3078 SW AVALON WAY

1.16.2014 RECOMMENDATION 2 PACKAGE 3078 SW AVALON WAY DPD PROJECT #:3013303

1.16.2014 **RECOMMENDATION 2 PACKAGE** 3078 SW AVALON WAY DPD PROJECT #:3013303

HEIGHT REDUCTION STUDY

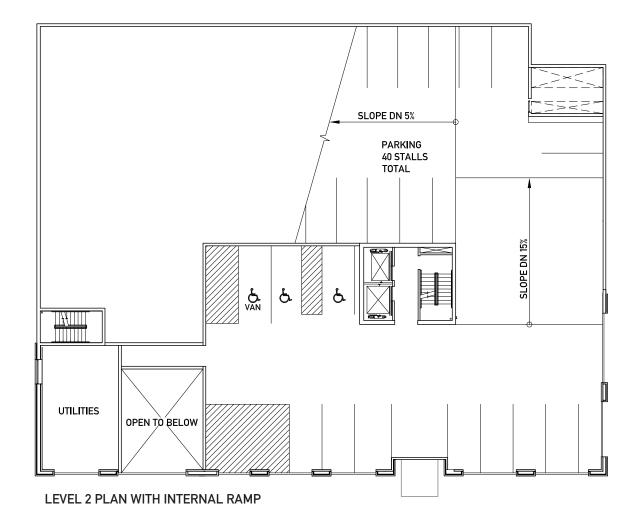
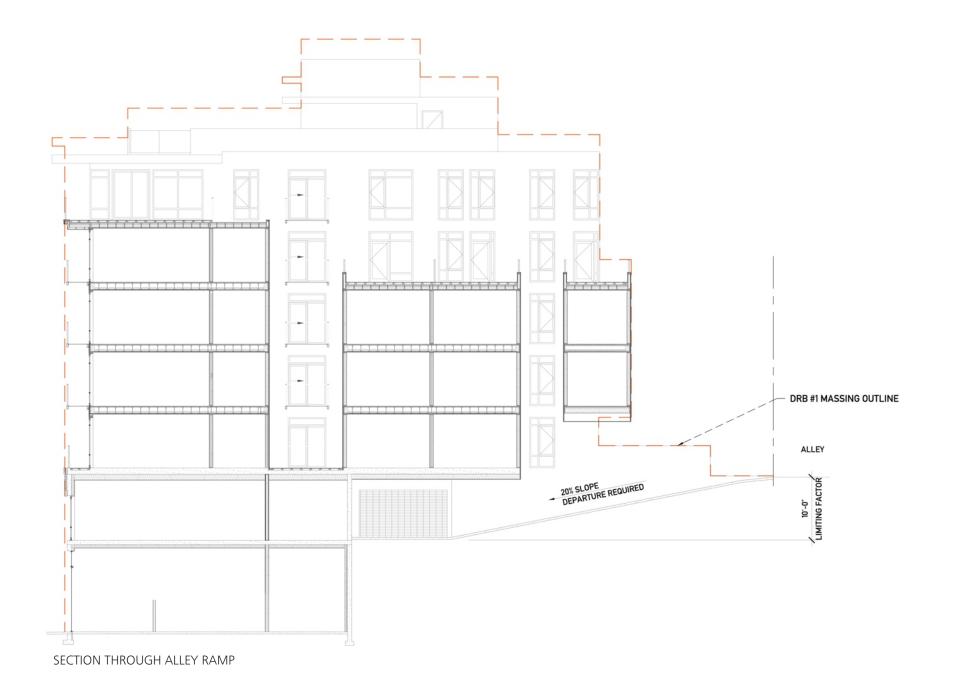
B-1 Height, Bulk, and Scale Compatibility At the Initial Recommendation Meeting, the Board applauded the reduction of the north wall length, and the elimination of the departure for Structure Depth. The Board appreciated the revised design is appreciably less bulky than shown at EDG, but requested the following two options (or a combination) be studied to further reduce the building height impacts, but did not request elimination of an entire floor of units: Reduce the current floor-to-floor heights to lower the top parapets 3-5 ft. Study pushing the parking deeper into the site, lowering the entire building, even if this means a steeper ramp off Avalon, and/or other implications which should be clearly shown as pros and cons at the next meeting. The Board realized a terraced courtyard might be one on these implications, to not create a moat along the alley.	Sections, Elevations	The floor-to-floor height has been reduced eight inches per floor, for a total reduction of 3'-2". A study was conducted regarding internal ramping and is included in this packet. Given the constraints of the site and the necessity for access from both the alley and the street, it is not feasible. The building under the allowed height limit by more than 4'-3".

Internal Ramp Pros:

- 4'-1" height reduction
- One parking area, not split
- No departure required for ramp slope
- No alley access

Internal Ramp Cons:

- Full redesign of lower two levels and courtyard
- Loss of street facing units
- 20' wide access required off Avalon Way
 All traffic directed onto Avalon Way
- Loss of 23 parking Stalls
- Loss of inviting lobby
- Courtyard up to 10' below alley grade
- Departure required for access from Avalon Way
- Increased excavation
- Nearly identical height reduction as proposed design
